MEMORANDUM

DATE: Tuesday, November 27, 2012
TO: Amana Construction
ATTN: Mr. Moses Wazwaz
PROJECT: 25 Empire Drive, St. Paul, MN
PROJECT NO.:
WRITTEN BY: Chris Scheevel

Background and Description of Structure

Photo 1: Failed Roof Truss

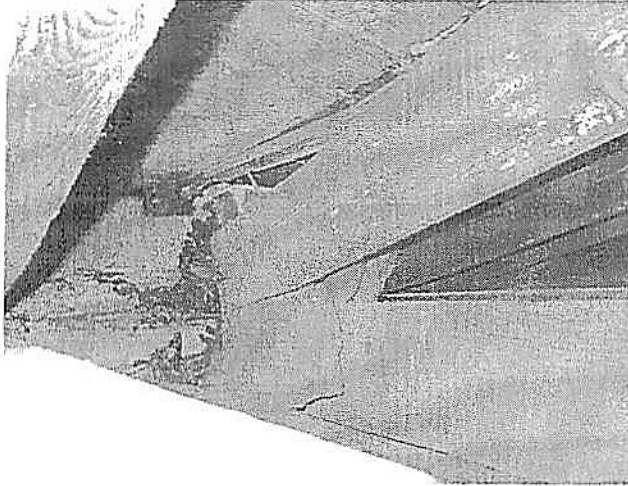
1. Several roof trusses are crushed at their end bearing on the south wall. Water stains indicate water penetration created a suitable environment for decay fungi to attack and weaken the trusses (Photo 1). There is no discernable strength in the trusses at this location. It is our professional opinion that these trusses pose an unsafe condition.
2. The exterior limestone walls are sufficiently bowed to require further analysis to determine the stability of the walls (Photo 2). The walls do not appear to present an unsafe condition but this cannot be verified without further analysis. This analysis is outside the scope of this investigation.
3. One of the steel members in the X-bracing system is buckled, possibly due to movement of the exterior walls.

1. The south ends of the roof trusses require shoring to prevent a sudden collapse. We recommend this shoring be accomplished immediately and before a significant snowfall. Please see the attached sketch for recommended shoring loads and locations..
2. Due to the bowing of the exterior limestone walls, we recommend the walls be analyzed to determine the wall stability under gravity and wind loads.
3. We recommend the X-bracing be analyzed to determine the cause of buckling, and reinforced or replaced, as required.
